Re: Docket Item #9, Greenhill West Alexandria CDD and MPA

Staff-Recommended Potential Condition Changes

Greenhill / West Alexandria CDD

Docket Item #9

Figure 7.12 Residential streets provide two shared lanes for cars and bicycles, with two parking lanes, a floating strip and sidewalk.

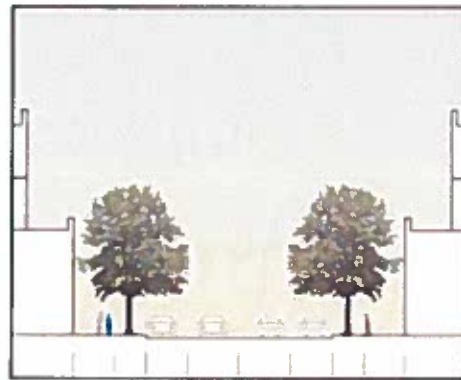
The new Required streets are the Main Street (Public Street C) and the Metro Street (Public Street A), not McConnell, so necessarily, McConnell would be considered just a residential street which calls for building face to building face to be 66 feet, not the full width that 21 additional feet of ROW would create. We already proposed completing the streetscape on the north side of the street with ROW dedication around 5 feet, not 21 as requested.

Exhibit 1 - Roadway Connection Not Preferred

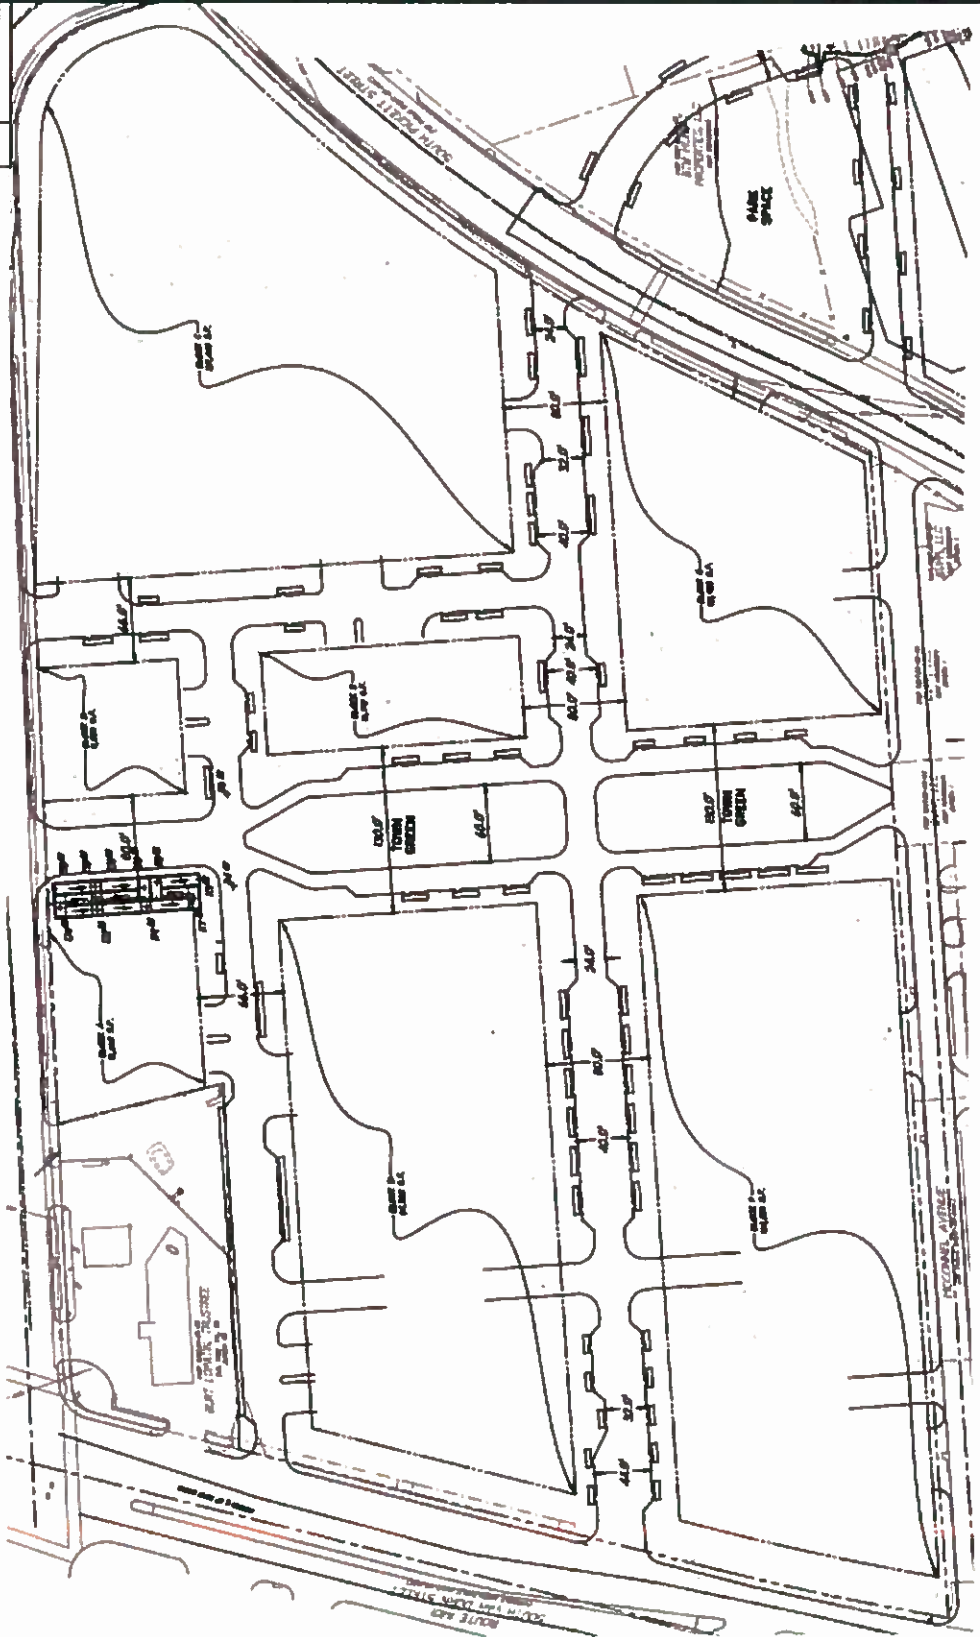
Condition 43 requires that the Applicant resubmit engineering studies to the City with the first DSUP showing whether connecting Public Street A to Edsall Road for vehicles is feasible and leaves it up to the Directors of P&Z and T&ES to determine if it is, and if so, requires a certain width of that street connection. The Applicant has already submitted engineering studies that show why connecting Public Street A to Edsall Road for vehicles is not feasible. The significant grade change that occurs from Edsall Road to Pickett Street is the cause. As you can see on Exhibit 1, attached hereto, we believe the vehicular connection is not advisable for several reasons.

- a. First and foremost, the change in grades between Edsall and the new Public Street “B” would cause the slope of that portion of the road to be at 14%, a slope not recommended on a regular basis by the Department of Transportation and Environmental Services. Vehicles coming up that 14% slope to the new intersection would be at a disadvantage moving into the intersection because they will have difficulty seeing vehicles approaching from both directions on Edsall Road as the drivers will be peering over the hoods of their cars at such a significant slope.

- b. In addition, in order to comply with the ADA requirements for the sidewalk between Edsall and the new Public Street “B”, significant switchbacks would be required that would take up the entire sidewalk area.

- c. If the City insists on pushing the street though to Edsall Road, with a 70 foot ROW, that takes a 15 ft. slice out of each of Blocks A&B. To reach the 200k minimum office use on these blocks, we would have to go to 7 stories in lieu of 6 as shown on the CDD Concept Plan.

- d. Further, based on our traffic impact analysis, the queuing for the westbound traffic on Edsall Road to the Van Dorn Street intersection will be backed up to this proposed intersection, making traffic back up further onto this new connection, eliminating the benefit of the new street which was to move local traffic around the new street grid.

- e. Finally, this street was listed on the Landmark Van Dorn Corridor plan as a local street, not a regional connector which it would necessarily become if the direct connection to Pickett and the multi-modal bridge is provided. The Applicant will be working towards creating a new, retail-focused neighborhood, and is concerned about the negative impacts of turning this park road into what would become a thoroughfare if it is directly linked to the new multi-modal bridge. All the traffic backing up on or around the Town Green will have significant negative impacts on the ability to make this a vibrant area and will likely have deleterious effects on the viability of new retail and park environment.
